DRAWING EXTRACT - SITE PLAN AS APPROVED
REF: 20/00616/FUL, 5th AUGUST 2020

DRAWING EXTRACT - SITE PLAN AS PROPOSED

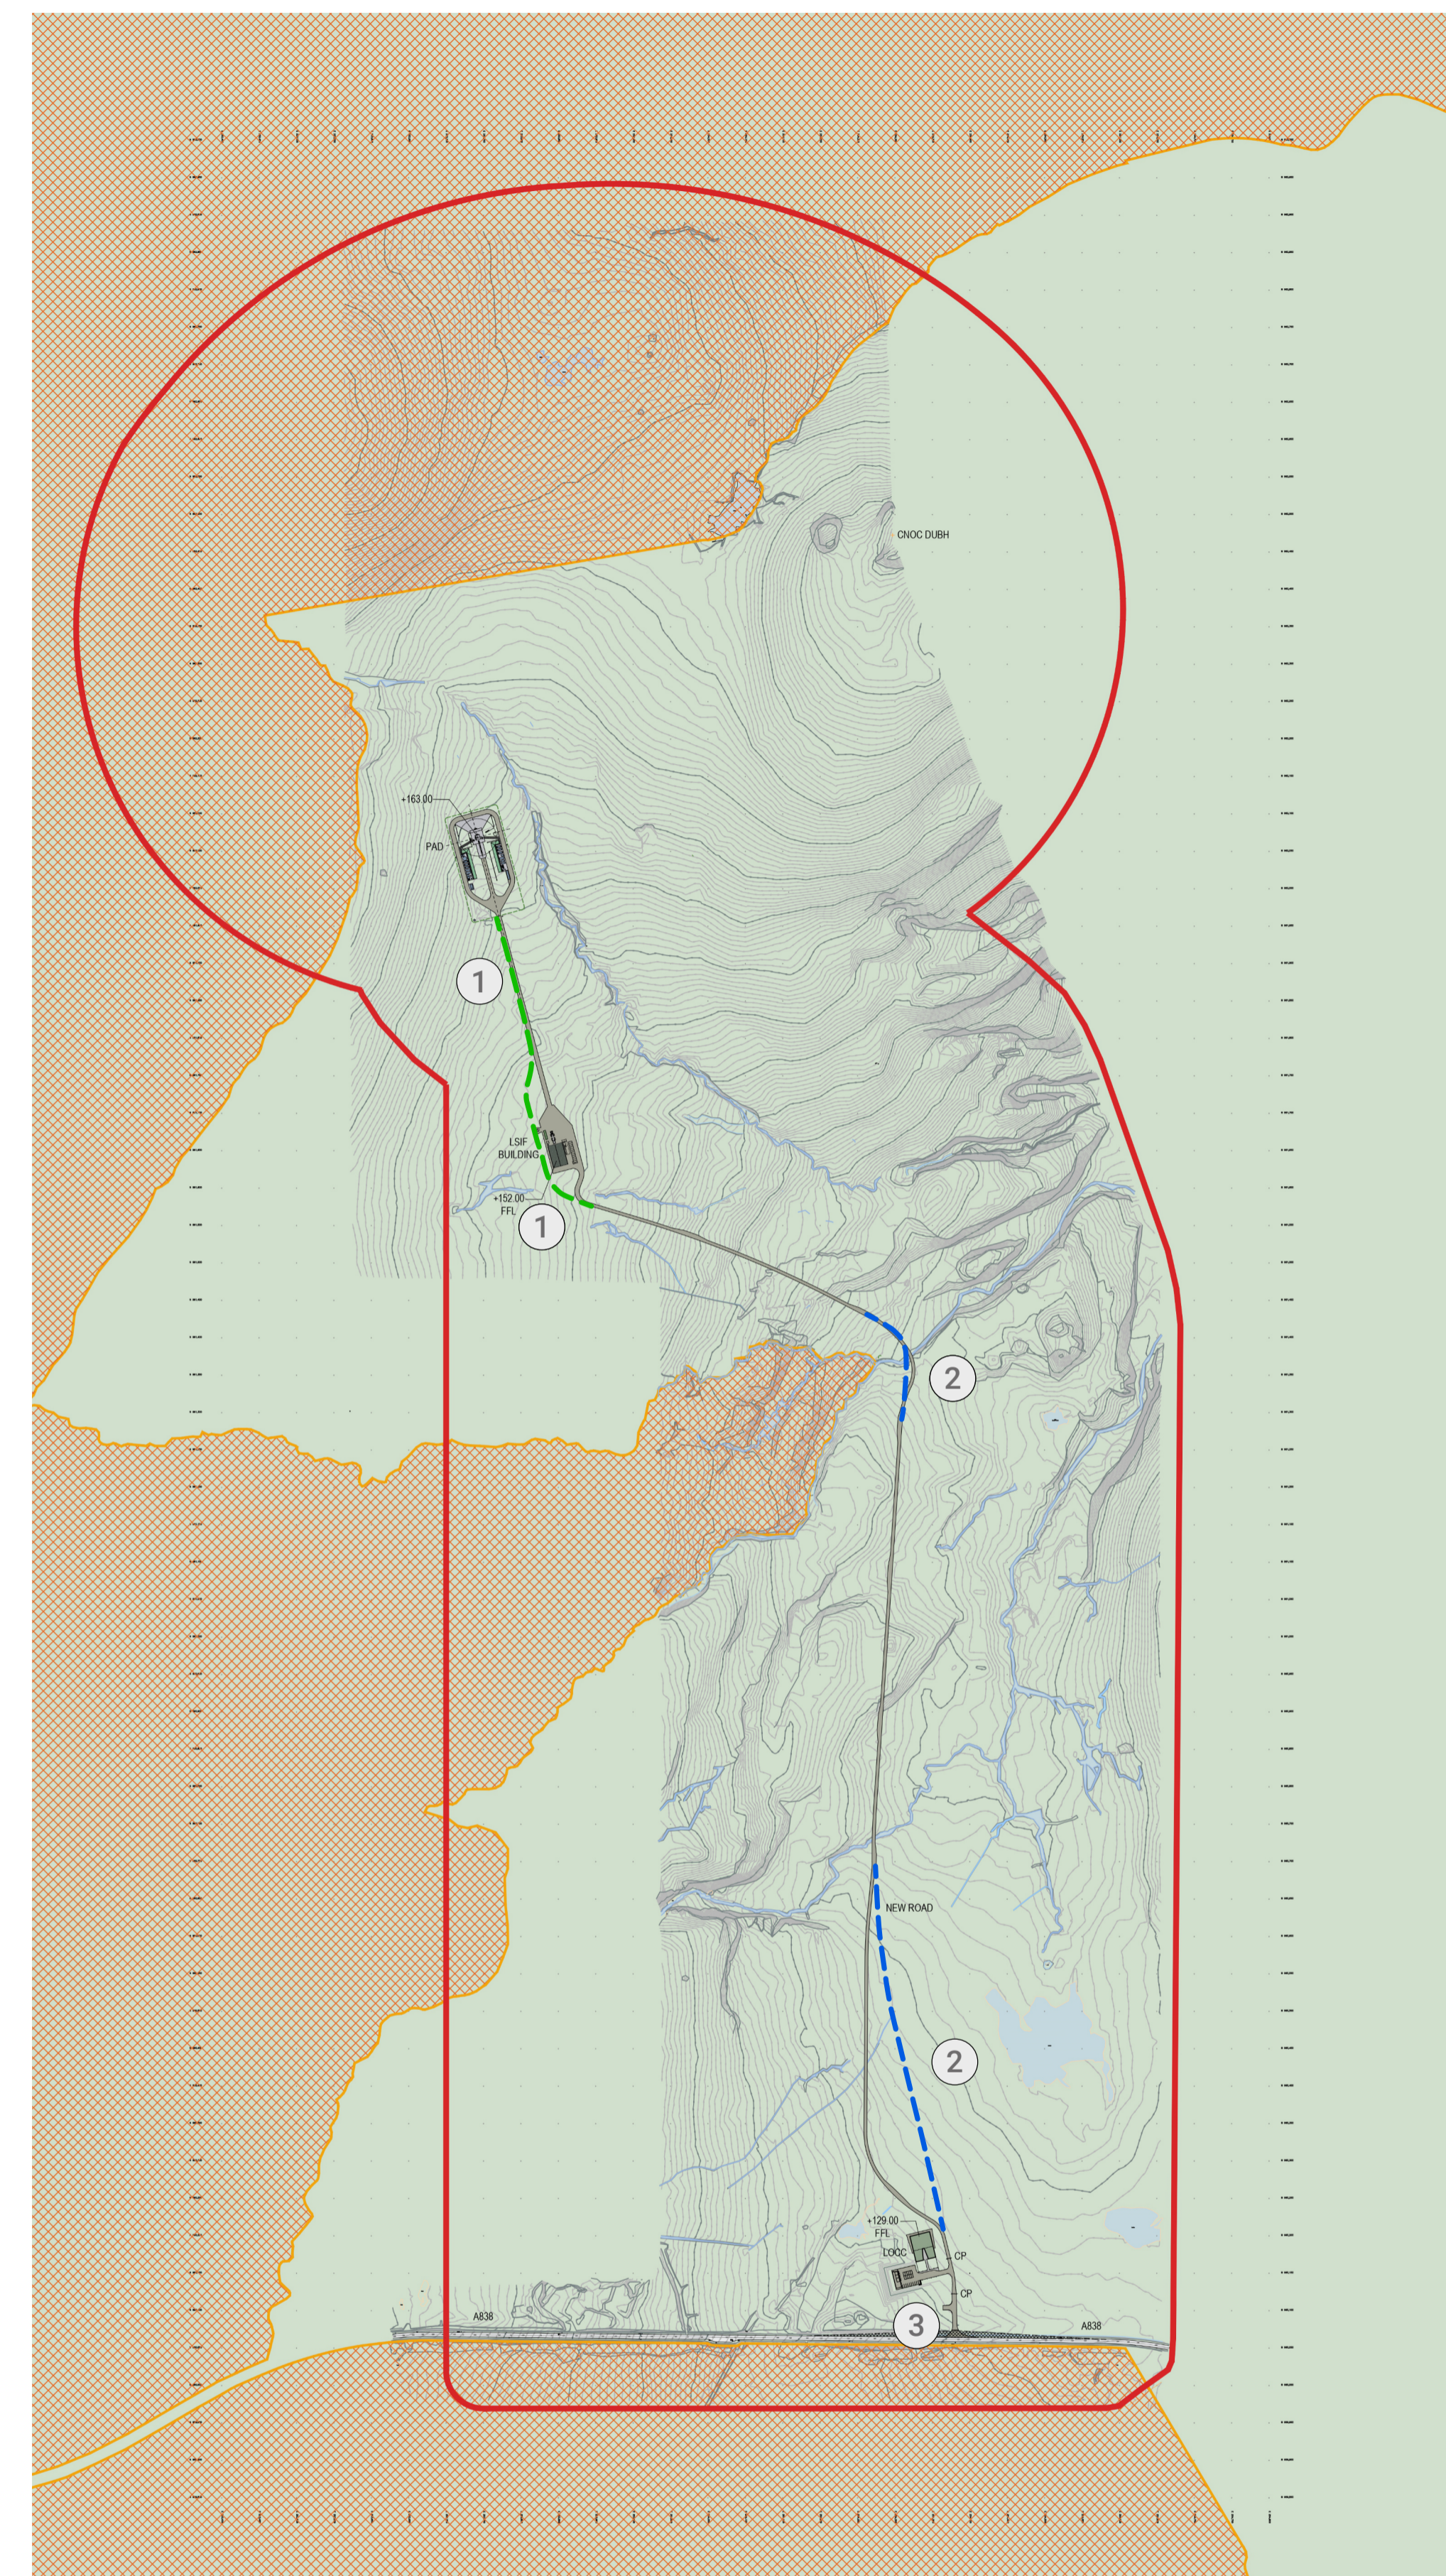
① ACCESS TRACK & RAIL TRACK LINK HAVE BEEN RATIONALISED TO A SINGLE TRACK, REDUCING PEAT DISTURBANCE AND VISUAL IMPACT

② PROPOSED TRACK HAS BEEN RE-ROUTED TO AREAS OF SHALLOWER PEAT, REDUCING PEAT DISTURBANCE AND ENVIRONMENTAL IMPACT

③ MINOR RE-POSITIONING OF TURNING HEAD
